Calvert Cliffs Nuclear Power Plant

SUBJECT: Calvert Cliffs Nuclear Power Plant
Unit Nos. 1 & 2; Docket Nos. 50-317 & 50-318
Response to NRC Request for Additional Information Regarding ASME Code
Relief Request to Authorize Use of Mechanical Nozzle Seal Assemblies at
Calvert Cliffs Nuclear Power Plant as an Alternate Repair Method

**RESPONSE TO REQUEST FOR ADDITIONAL INFORMATION
MECHANICAL NOZZLE SEAL ASSEMBLY**

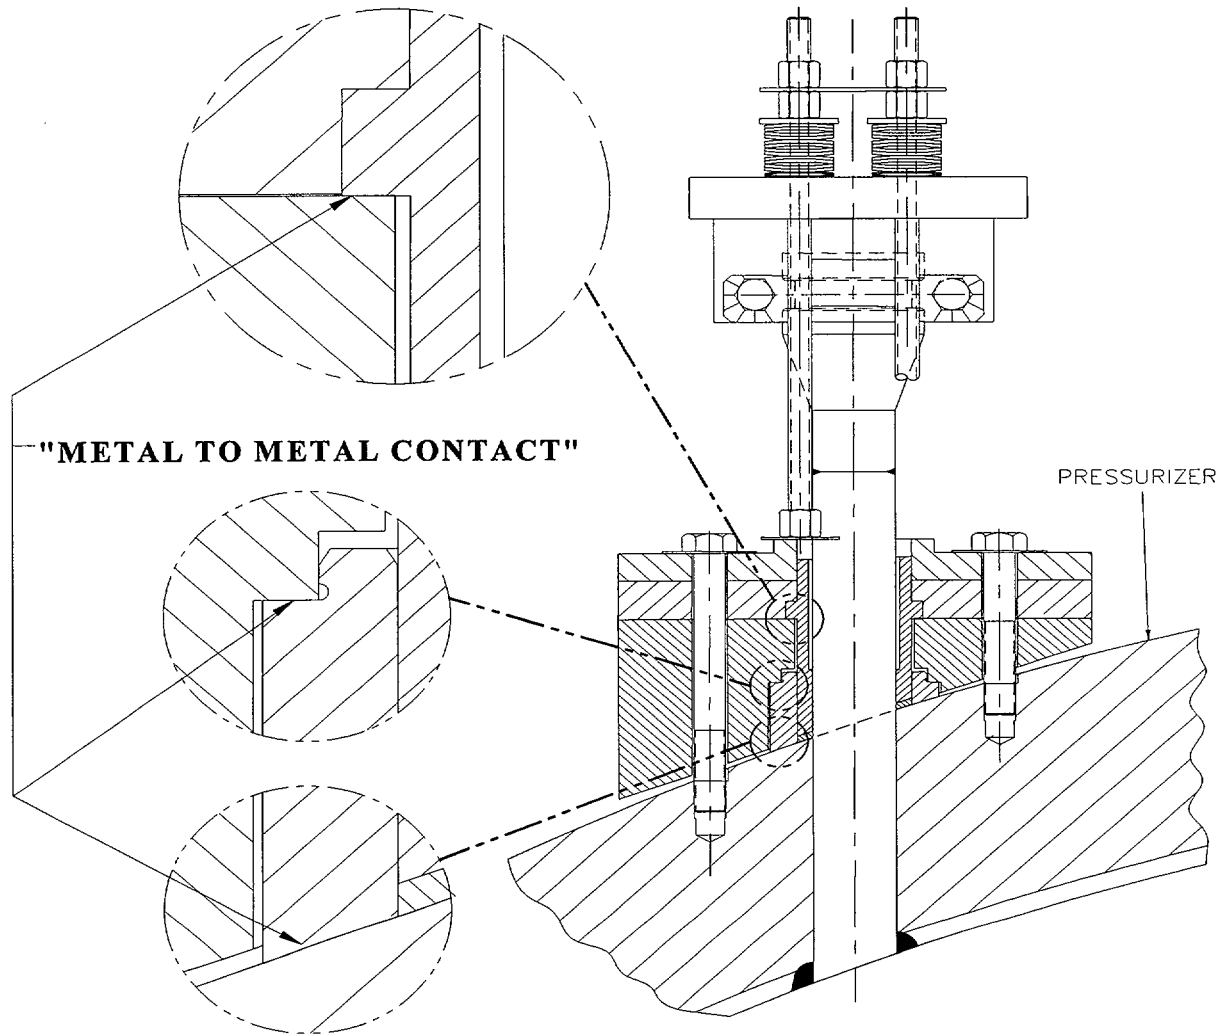
Reference (2) states that additional thermal test cycles are not considered necessary since the MNSA components are designed to go "metal-to-metal," confining the graphite seal in a fixed volume, and that thermal cycling does not "work" the seal; and, therefore, the MNSA design is not sensitive to thermal cycling effects.

- a. Provide a description, including a diagram, of what is meant by "metal-to-metal."
- b. Provide test data or analysis to support the assertion that "thermal cycling does not work the seal" by showing that the graphite seal experiences zero thermal expansion or contraction under varying thermal conditions.

- a. A detailed schematic of the area of concern is provided below.

- b. The Grafoil seal is captured in a small volume that will not vary except microscopically. The bolt preload maintains the pressure and captures the seal to a nearly constant volume. Similar seals are being used in a variety of applications (valve stem seals) under significantly more thermal volume changes. Grafoil, therefore, can be considered to be a relatively stable seal material, especially when the volume changes are minor. Assuming an annular section of 1/4" (width) x 1/4" (height) x 1.1" (diameter), the volume is computed as $1/4 \times 1/4 \times 3.14 \times 1.1 = 0.215875 \text{ [in}^3\text{]}$. Then, assuming an expansion coefficient of $6\text{E-}6 \text{ [in/in-Deg]}$, and a temperature differential of 500°F , each dimension changes as follows:

0.250" expands to 0.25075" and
1.100" expands to 1.1033".

The total volume of the Grafoil seal is then $0.2178237 \text{ [in}^3\text{]}$, which equals a percentage change of $(0.2178237 - 0.215875) / 0.215875 \times 100 = 0.9 \text{ [%]}$. Thus, even neglecting the thermal

expansion of the Grafoil seal, the total volume is well within the initial compression of the Grafoil seal (approximately 35%).
